Access Compliance Report Public Rights-of-Way (Curb Ramps)

Intersection ID: 19432 Main Street: REXFORD_RD Cross Street: COCA-COLA PLAZA Location: SE

ADA ID: CEDCC59666C6 Ramp Type: Perp Initial Pass/Fail: Fail Overall Compliance: No Severity Score: 13.75

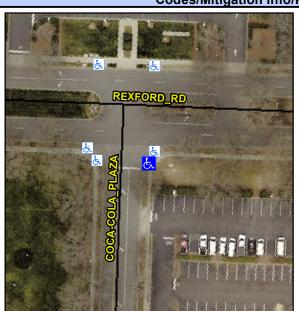
Not Found, R304.2.2, R304.5.3

Field Measurements/Component Compliance								
Comp	liance Description	Data	Comp	liance Description	Data			
N/A	Ramp Length (in)	127.0	No	Ramp Slope (%)	9.0			
Yes	Ramp Width (in)	48.0	No	Ramp XSlope (%)	2.5			
N/A	Flare Type LT	N/A	N/A	Flare Type RT	N/A			
N/A	Flare Slope LT (%)	N/A	N/A	Flare Slope RT (%)	N/A			
N/A	Flare Traversable LT?	N/A	N/A	Flare Traversable RT?	N/A			
N/A	Landing Length (in)	N/A	N/A	DWS Provided?	N/A			
N/A	Landing Width (in)	N/A	N/A	DWS Contrast?	N/A			
N/A	Landing Slope (%)	N/A	N/A	DWS Length (in)	N/A			
N/A	Landing X Slope (%)	N/A	N/A	DWS Full Width?	N/A			
N/A	Landing Curb? (Y/N)	N/A	N/A	DWS Offset (in)	N/A			
N/A	Shared Landing?	N/A						
N/A	Gutter Ponding?	N/A	N/A	Gutter Slope (%)	N/A			
N/A	Gutter Lip Ht (in)	N/A	N/A	Gutter X Slope (%)	N/A			
N/A	Painted X Walk1?	No	N/A	Painted X Walk2?	N/A			
	X Walk 1 Direction	To W		X Walk 2 Direction	N/A			
N/A	X Walk 1 Width (in)	N/A	N/A	X Walk 2 Width (in)	N/A

Remove & Replace Entire Ramp.
